**Report of an Independent Federal Review Team on  
Management of Dredged Material Disposal Sites at the  
Mouth of the Columbia River, Oregon/Washington**

**19 October 2001**

**Errata:**  
**Report of an Independent Federal Review Team on Management  
of Dredged Material Disposal Sites at the Mouth of the Columbia  
River, Oregon/Washington**

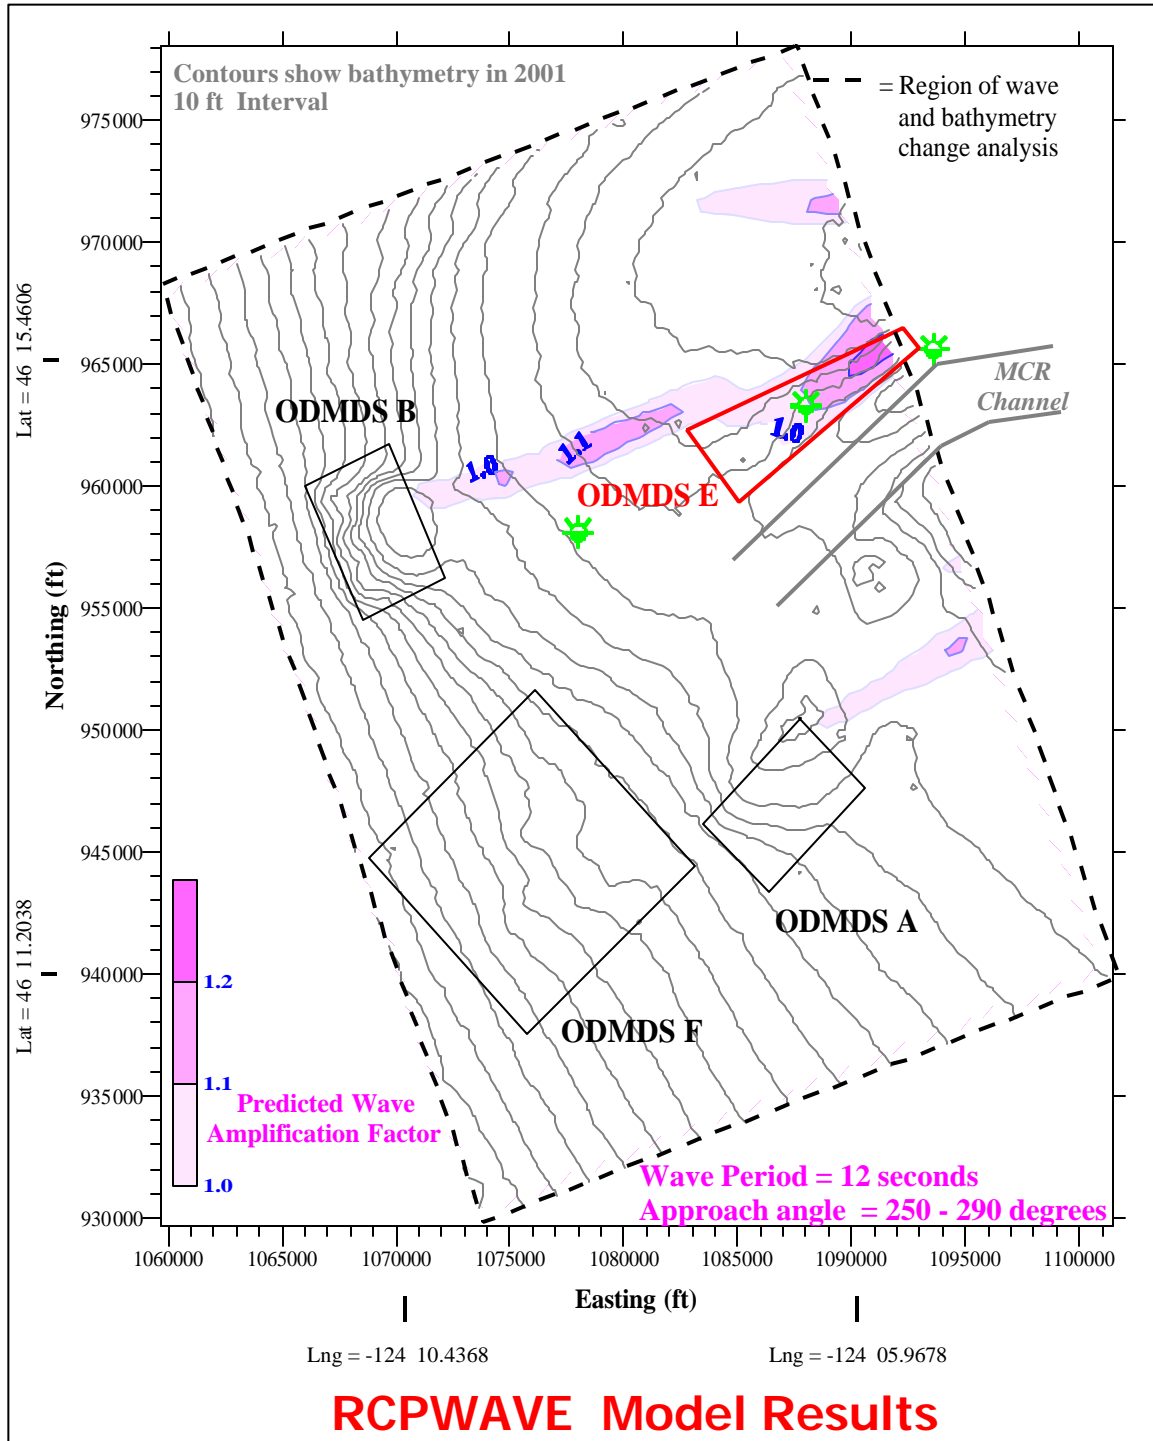
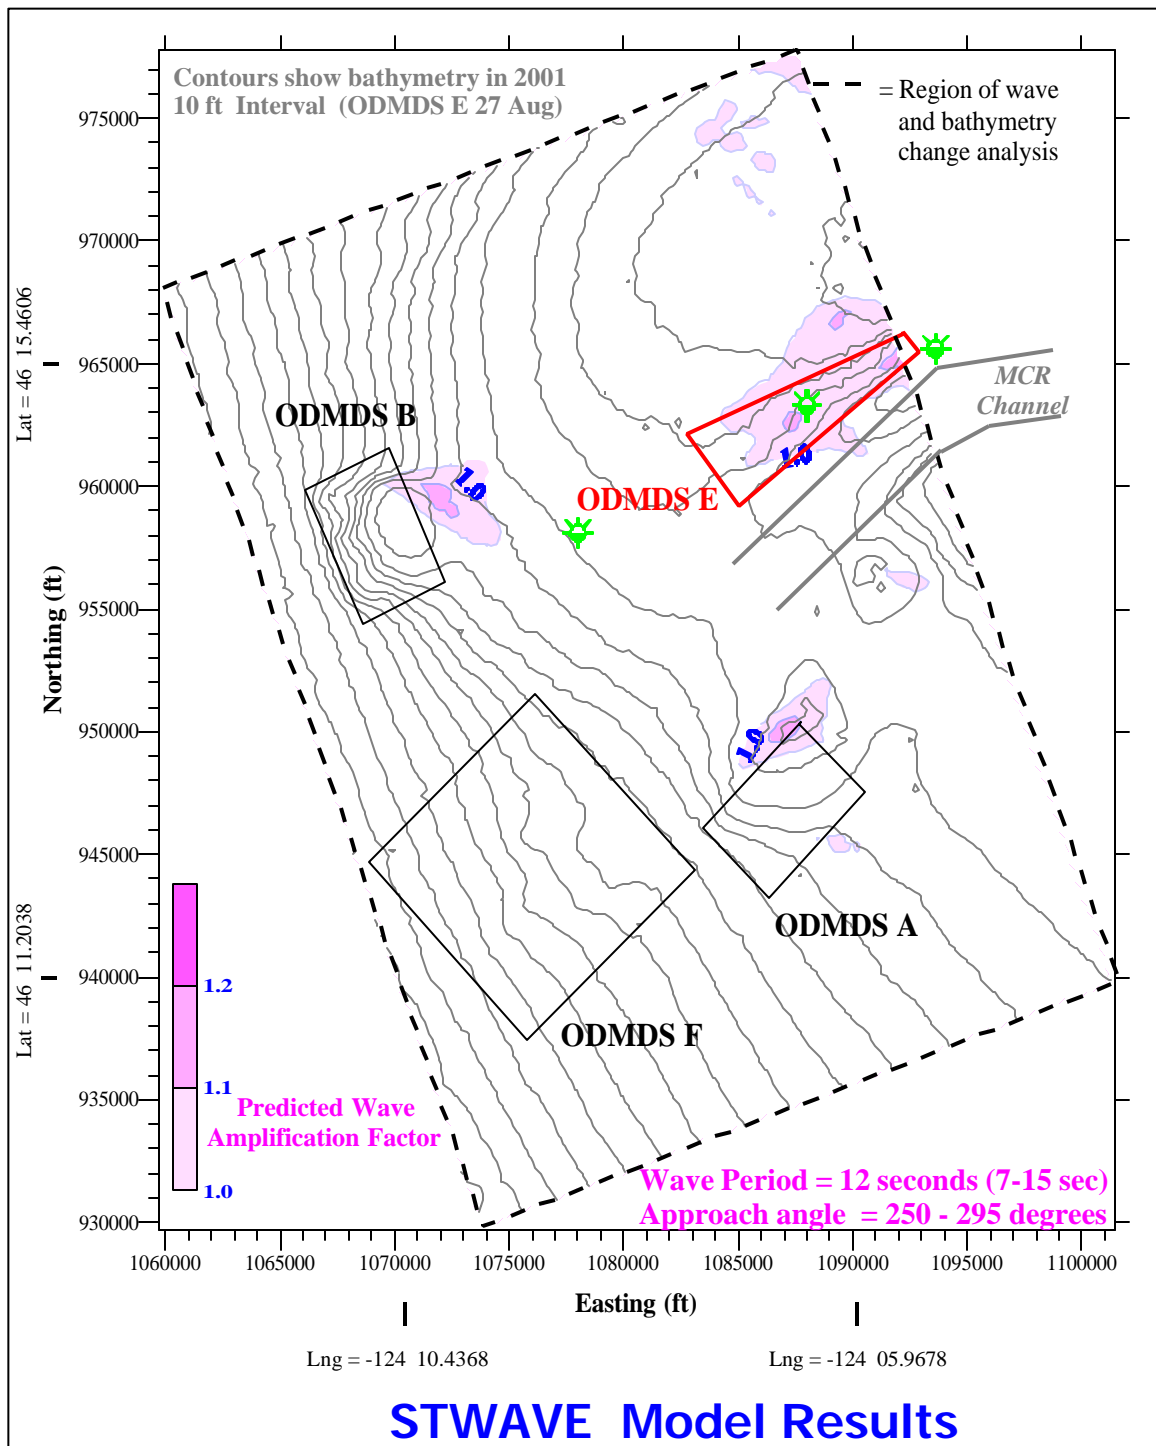
In the original October 19, 2001 report, Figure 12 was incorrectly identified as representing wave response to bathymetric conditions for 2000 and thus to compare well with 2000 conditions shown in Figure 11. In fact, however, Figure 12 represented 2001 conditions and the wave approach angles were also different. The attached replacements for Figures 11 and 12 show the results of modeling based on comparable bathymetric and incident wave approach conditions in 2001. The following text changes relate to these replacement figures.

On the 6<sup>th</sup> line in the 1<sup>st</sup> paragraph of Section IV F 2. STWAVE MODEL, change “Figure 11.” to “Figures 11 and 12.”

On the 5<sup>th</sup> line in the 1<sup>st</sup> paragraph of Section IV F 3. LIMITED AREA OF INFLUENCE, change “2000” to “2001”.

On the 9<sup>th</sup> line in the 1<sup>st</sup> paragraph of Section IV F 3. LIMITED AREA OF INFLUENCE, change “Natural accretion on the north portion of Peacock Spit created a potential amplification area much larger than did the bathymetric changes in Site E.” to “Natural accretion on the north portion of Peacock Spit created a potential for amplification in the fourth and most northerly area.”

On the 5<sup>th</sup> line in the 4<sup>th</sup> paragraph, *Multiple models*, under Section IV F 4. RECOMMENDATION TO DETACH CONSIDERATIONS OF WAVE MODIFICATIONS FROM DREDGED MATERIAL DISPOSAL DECISIONS, change “in Figure 11” to “by comparing Figures 11 and 12.”

**Figure 4.a. Contract Disposal Site E in 1999.**

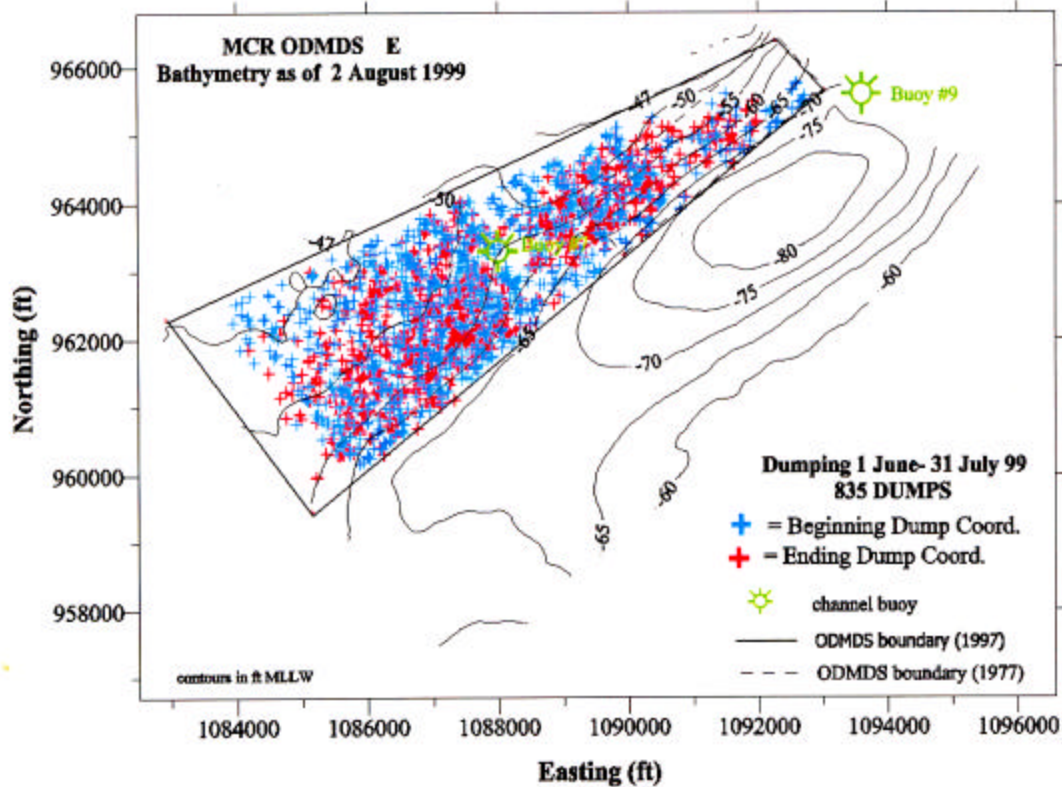
*Site E Placement in the E2 (Western Zone).* A contract is let each year for MCR dredging and disposal in Site E2 for approximately 1.5 mcy. To achieve the management objective of even dispersal of material with minimal mounding, Site E was divided into cells (Figure 3). Site E1 was divided into 75 cells and E2 into 123 cells. Comparisons of disposal in 1999 and 2001 for the contract hopper dredge show clearly the attempt to

maximize disposal within the site boundary (Figures 4a and 4b). Note avoidance in the northern portion of E2 and the center of E2 in 2001. Both areas had significant accumulations in 2000, which had not significantly eroded, by the May 2001 survey. As a result, these areas, as well as the separation region between E1 and E2, were identified to the contractor prior to disposal as areas of no placement (Figure 5).

**Figure 4.b. Contract Disposal Site E in 2001.**

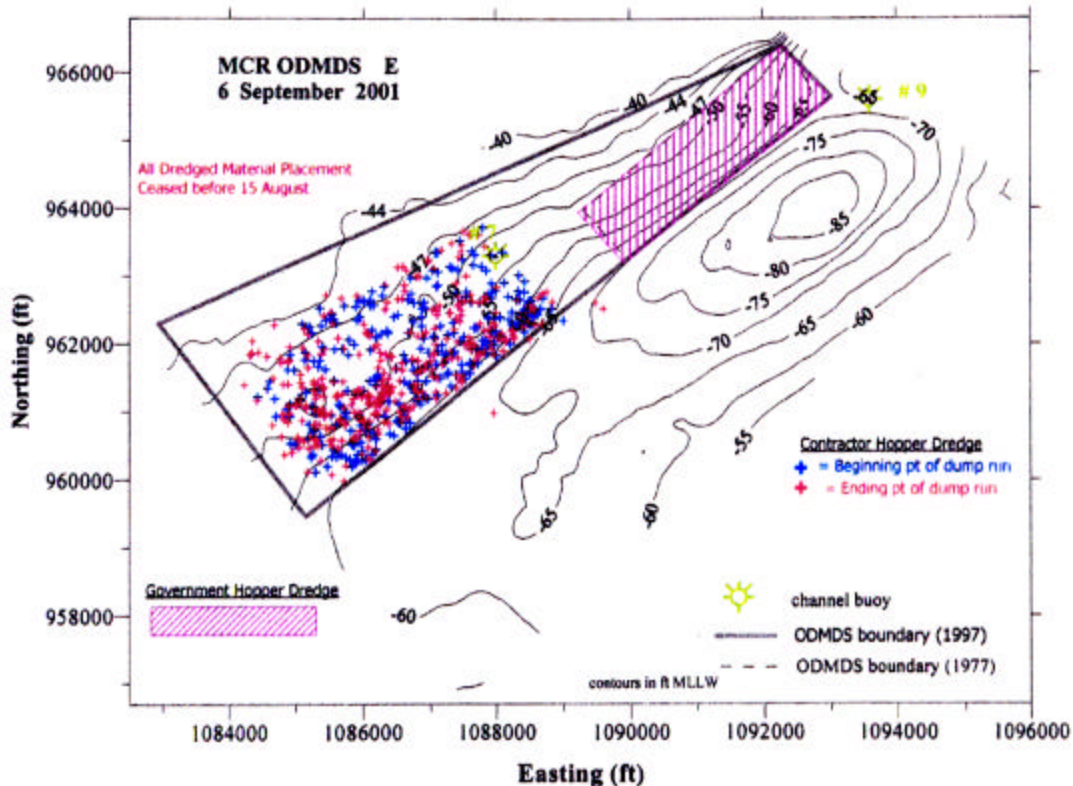
A comparison from May through August of 2001 for E2 indicates a fairly good spread of material over E2 to the vertical management limit of 5 feet. Another comparison between July 30 and August 19 difference plots shows how quickly the site reached capacity, and illustrating the need to have tight triggers on all disposal as the site reaches capacity (Figures 6a and 6b). The areas that exceeded the five foot management limit are illustrated in the figures with a bold yellow line in figure 6a and a bold blue line in figure 6b.

In addition to direct accumulation at the point of disposal, secondary accumulations due to sediment migration within the site were also observed. All contract dumping in E2 in 2001 was from a split haul hopper dredge with a high discharge rate (1-5 minutes). When comparing the differences plots to the discharge plots, it is observed that wave and current dynamics play a significant role, especially along the northern portion of E2.

Although no discharge occurred along the northern cells, a significant portion of this area nevertheless reached the plus five feet level. The use of modeling may be able to assist in the prediction of sediment transport and would be a good tool in optimizing site capacity in conjunction with the existing surveys.

**Figure 7. Difference plot for August 27, 2001.**

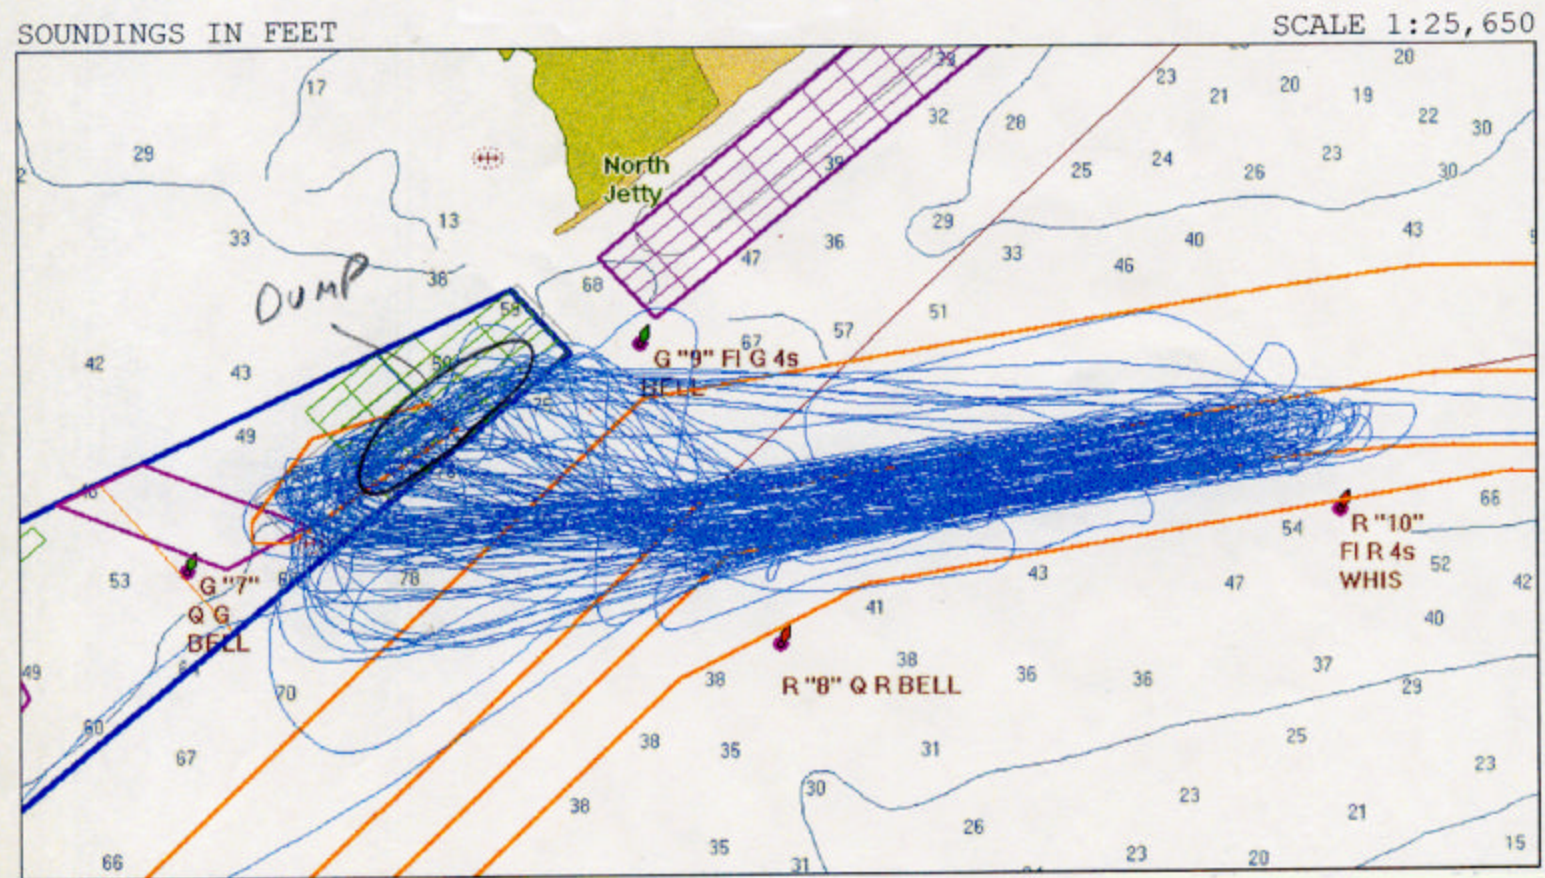
Last, it was noted that portions of E2 exceeded the 5 foot limit after the completion of dumping at E2 (Figure 7). As in previous figures, the area exceeding the 5 foot management limit is outlined. However, Site E2 seems to be very well managed and with a few minor exceptions identified above, was at optimal use (given the management targets in place). As will be addressed in further detail in another section of the report, the Corps should address the issue of altering the 5 foot limit so that the government does not appear to be in non-compliance where there is no real safety issue.

**Figure 10. Historical erosion trends of Peacock Spit.**

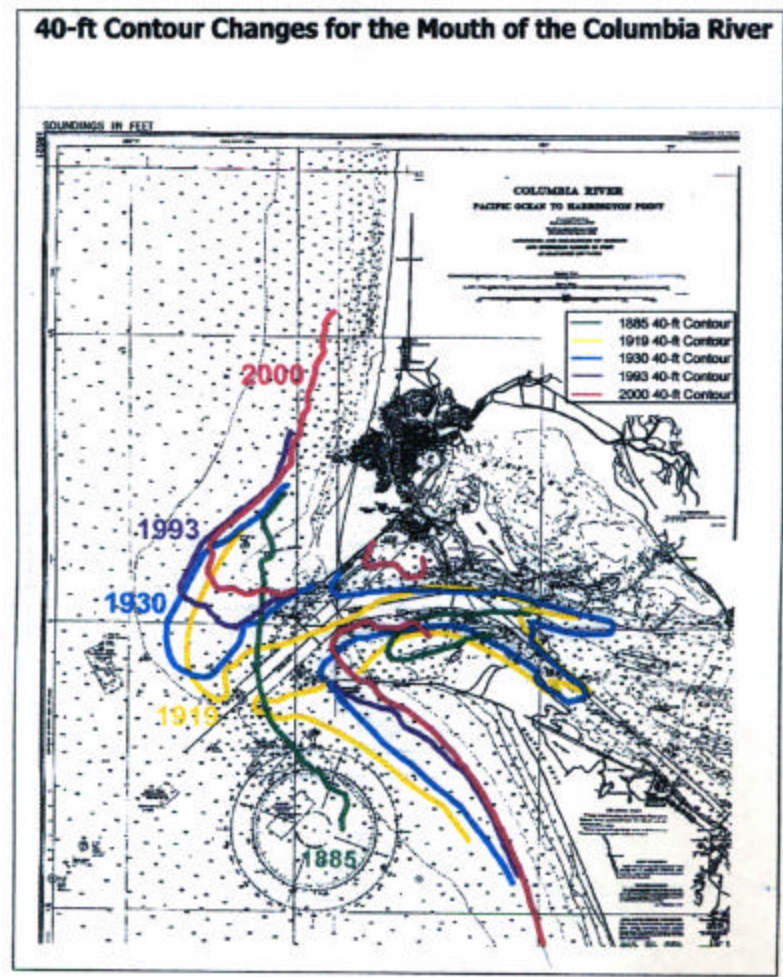
In the Review Team's opinion, management of Site E should focus on balancing the goals of keeping dredged material in the near shore zone against the need to *not unacceptably increase risks* to vessels transiting the area (in contrast to a hypothetical goal of *providing for* vessel safety). Peacock Spit has been undergoing substantial long-

term erosion throughout the last century (Figure 10). It is unlikely that erosion of the Spit or the up-coast shoreline could be completely eliminated even if all the sand dredged for MCR O&M were to be placed at Site E. However, any sand placed there (and at the Jetty site) will help to retard the *rate* of sand loss from the system. At the same time, it is unlikely that even complete elimination of the use of Site E would substantially reduce existing risks to vessels transiting the area, because Peacock Spit would continue to exert a predominating influence on wave climate there for decades to come.

*Real Hazard on Peacock Spit.* The large natural shoal off MCR is Peacock Spit (Figure 10). It is a chronically eroding remnant of the pre-jetty ebb shoal. Ebb shoals are naturally occurring deposits that occur at inlets and estuary mouths wherever tidal and wave forces oppose one another. They usually take the form of a crescentic bar. For most of the last century the former ebb shoal has been eroding (Figure 10) creating deeper water to the northwest of MCR. The deeper water allows larger unbroken waves to impinge on the tip of the North Jetty. Damage to the jetty is increasing not only because of greater wave exposure, but also eventually because of undermining as the jetty foundation becomes threatened. If unchecked erosion would eventually provide deep water and thus might appear to offer future improved navigation conditions for boats turning north just beyond the jetties. Disposal in Site E slows these processes, but helps maintain jetty stability. Under present conditions and even if erosion of Peacock Spit proceeds to the point of jetty collapse, the hazardous wave conditions for boats taking a shortcut to northern areas would not be encountered in Site E, but a mile or more to the north on Peacock Spit as illustrated by the large area of wave breaking shown in Figure 14. Our other wave-related figures shows changes in wave conditions compared to 1997. Figure 14, in contrast, shows actual as well as changed conditions. The modeled waves did not break in Site E in 1997, but did along a small portion in 2000. In both years, however, there were large areas of breaking to the north. This breaking was not a direct result of any disposal (Figures 11 and 12). If a vessel were to avoid the large area of breaking on Peacock Spit, Site E could also be avoided with little or no added transit time to or from nearshore areas to the north.

Figure 11. RCPWAVE model estimate of potential for increased focusing between 1997 and 2000 (Figure and modeling by NWP).

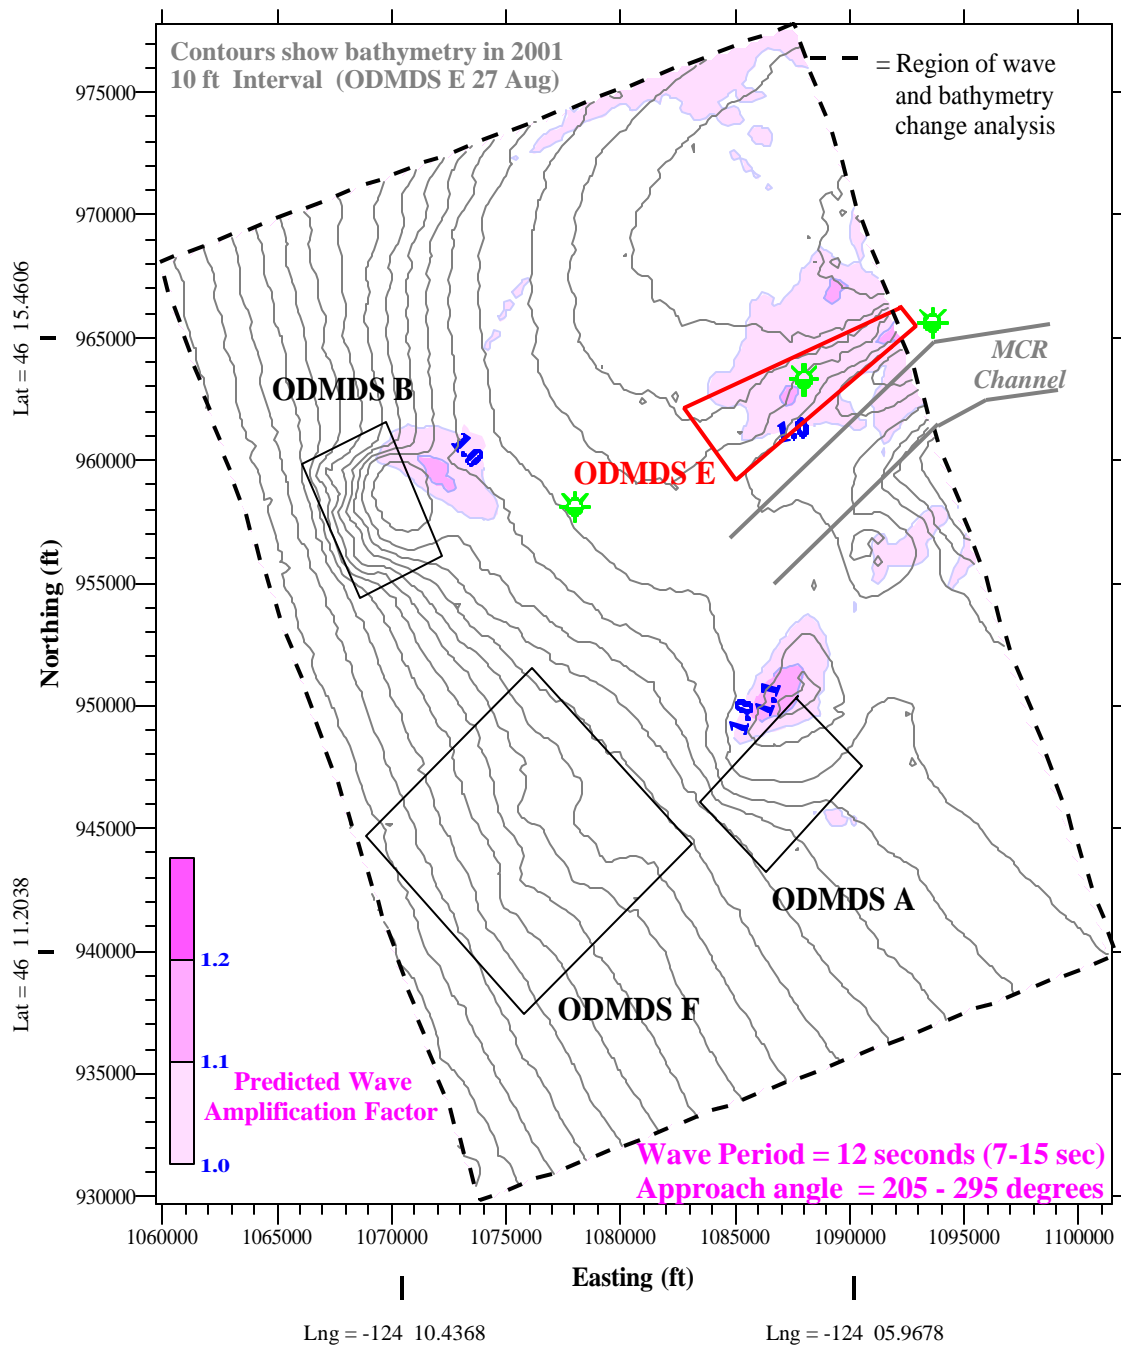
The amplifications shown in Figures 11 and 12 are due to natural and dredge-related bathymetric changes. Figure 11 shows four large areas of change. It is safe to say that all but the most northerly of these amplification areas are due to dredged material disposal. The most landward of these three areas occurs because of the material placed in Site E between 1997 and 2000. The other two are because natural changes eroded southern sides of the prominent dredged material mounds at Sites A and B and moved this material to the north over this same period. The lateral extent of amplification tends to be exaggerated by RCPWAVE. Note, however, that disposal in E created a potential for amplification above 10% that extends no more than 2500 ft outside of Site E. Natural accretion on the north portion of Peacock Spit created a potential amplification area much larger than did the bathymetric changes in Site E. In the longer run, the purpose of returning sand to the littoral system is to reduce erosion of the sub-aerial beach and the submerged portion that supports it. Over many years, as tens of millions of cubic yards of sediment are kept in the littoral system, the hope is that this action creates a significantly wider shore than would be the case if dredged material were taken out of the littoral system. We do not expect these much larger changes will create any boating hazard because safe navigation requires awareness of actual sea conditions, not hypothetical ones that would have existed if erosion had proceeded unchecked.

*Multiple models.* Models used to apply each theory add an additional layer of abstraction or idealization. Figures 11, and 12 illustrate the magnitude of differences obtainable with just two of many possible models. RCPWAVE does not model as many features of wave transformation as does STWAVE and typically over estimates the height of refracted waves as seen in Figure 11.
